Subject: revised version submission

We are very pleased to re-submit the attached manuscript “Rain concentration and sheltering effect of solar panels on cultivated plots» as a research paper to be published in *Hydrology and Earth System Sciences*.

Anonymous Referee #1

Figure 1 : rain depths (mm) collected in the two lines of collectors (“Ligne 1, Ligne 2)

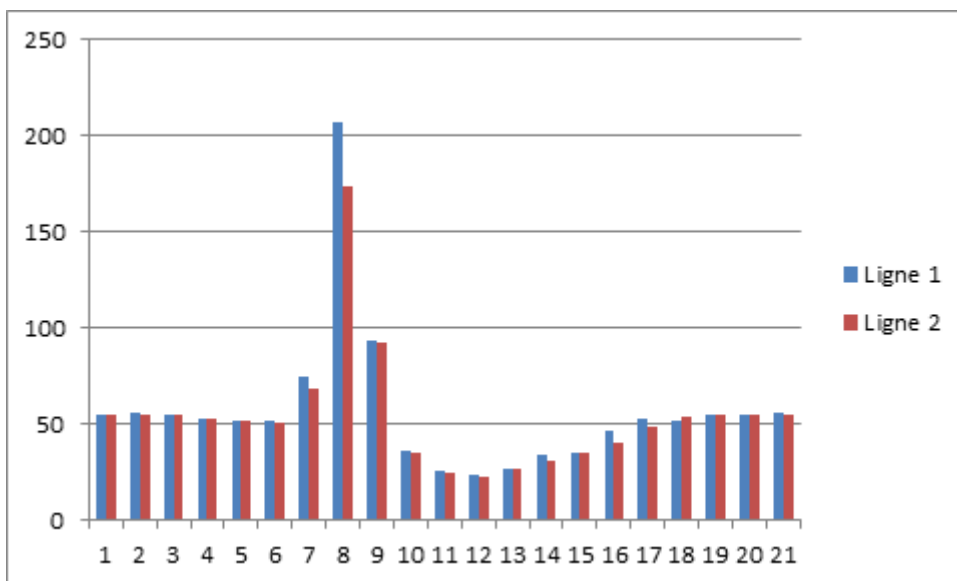
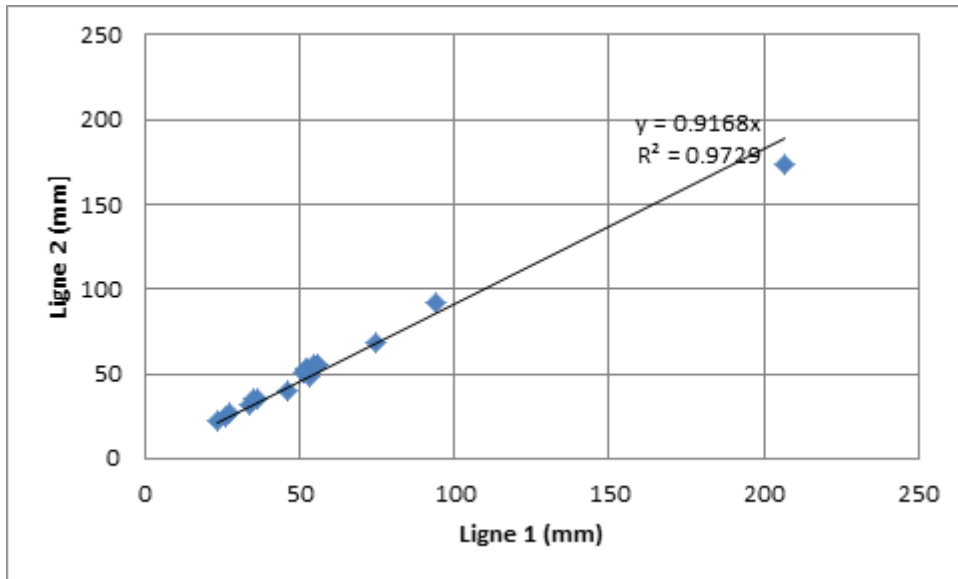
Line 129 and Fig. 1: For a better evaluation of distribution uniformity under the solar panels it would be better to use a grid of collectors or replicate the series of 21 collectors more times along the PV row. The results here reported should be considered partial. See also the comment below on the use of coefficient Cv.

Authors: We used a second series of rain collectors indeed for event #12. The results we very close to each others in the two series of collectors (see below).

Figure 2 : correlation between rain depths collected in the two lines

Due to the time necessary to collect all the samples, we could not increase the sampling, so we agree to indicate them as partial. The results could be used nonetheless to check the validity of the model AVrain, where no calibration was necessary to fit on the data (for any of the 12 rain events described in the manuscript).

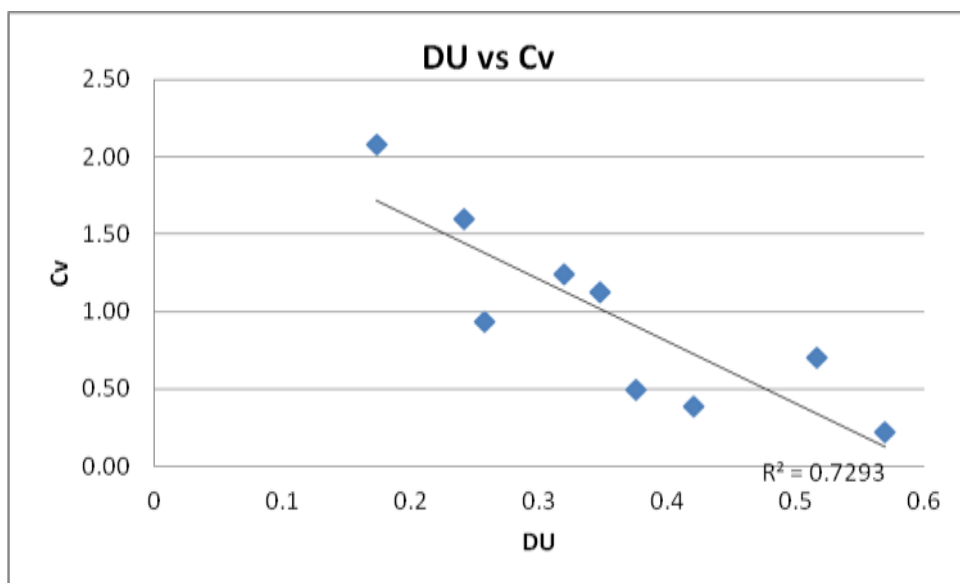
Lines 259-268: I think that the coefficient of variation Cv here cited by the authors is the manufacturer's coefficient of variation or a measure of discharge of a random sample of emitters useful for microirrigation system design. It doesn't describe the uniformity of water distribution by the irrigation system. In this case it is more appropriate the use of the low-quarter distribution uniformity DU also reported in Burt et al. (1997). But in this case it would be better to have data collected in a grid of collectors. The authors are invited to better explain and justify their choice.

Authors: There are indeed different manners to estimate the uniformity of application. Notably Christiansen's uniformity coefficient defined as:

$$UC = 100\% \left(1 - \frac{\text{average deviation from the averaged depth}}{\text{overall average depth of application}} \right)$$

is a widely used method of uniformity evaluation for sprinkler systems (Burt et al. 1997). Our coefficient of variation is merely related to UC: $Cv=1-UC$

The advantage of using UC (or Cv, which is equivalent) is that the uniformity of rain application due to panels can be compared to the one caused by usual spray irrigation systems.

It is however interesting to use other uniformity indicators as suggested by the reviewer, such as DU. DU will use the average of the lower quartile, so the rain depths obtained under the solar panels.

Obviously, DU and UC (or Cv) are correlated, as also reported in Burt et al. (1997). This can be observed in the figure below.

Therefore, both methods will give similar conclusions. The final version will include a remark about that.

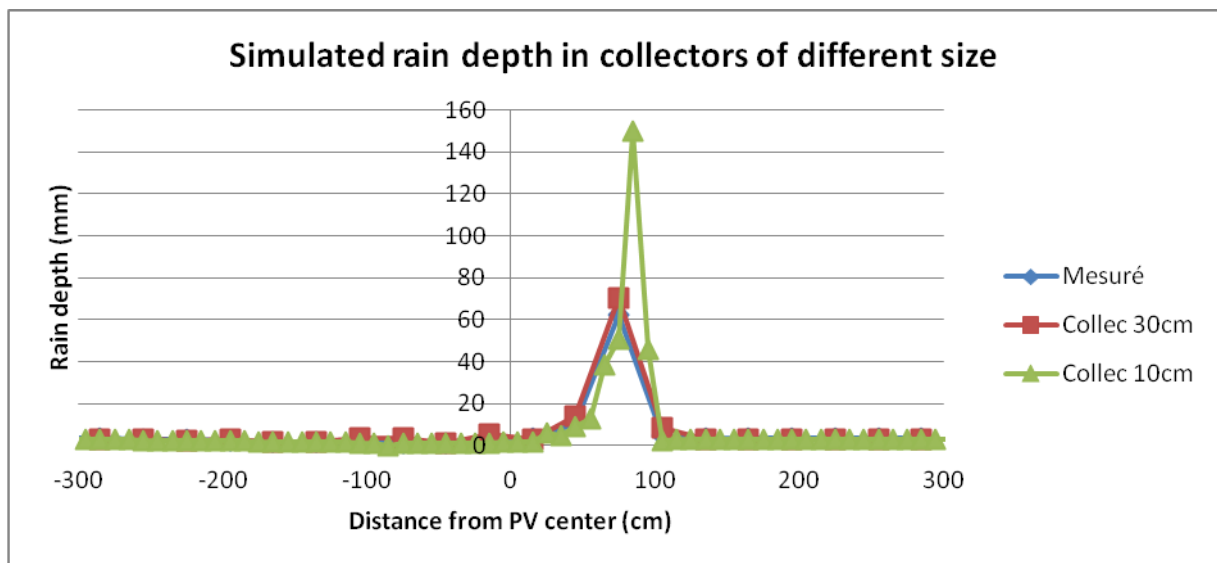
R2: 4. Discuss other factors like shading by panels, that may be more important for crop production than spatial heterogeneity of water distribution in crop fields. Shading cannot be controlled as the panel needs to face the sun, while water availability could be managed easily by providing additional irrigation. It would be great if the authors could discuss more on the relative role of these two factors. In arid and semi-arid regions, the redistribution of water could be an important factor compared to shading by panels. In fact, in extremely arid regions the crops might benefit from shading.

Authors: We fully agree with the reviewer. These factors are analyzed in a separate paper under review (so, not referenced here). Different strategies can be applied during rainfall events compared to the normal strategy (which are electricity- or crop-oriented strategies). We realized that hydrological heterogeneity was high in our Mediterranean context (with characteristics of semi-arid climate), so it was important to characterize this heterogeneity and its link to panel operation, and, in turn, to derive a model predicting rain distribution under movable panels. This led to design the avoidance strategy that applies only during the rain events.

The other points developed by the reviewer need specific instrumentation to understand the effect of radiation variations on crop evapotranspiration, and specific developments to adapt classical water balance models to the conditions imposed by solar panels. AVrain model will be an input of the crop-water balance model, but other adaptations will be needed regarding crop development and water consumption. Obviously, this must be treated in a separate paper.
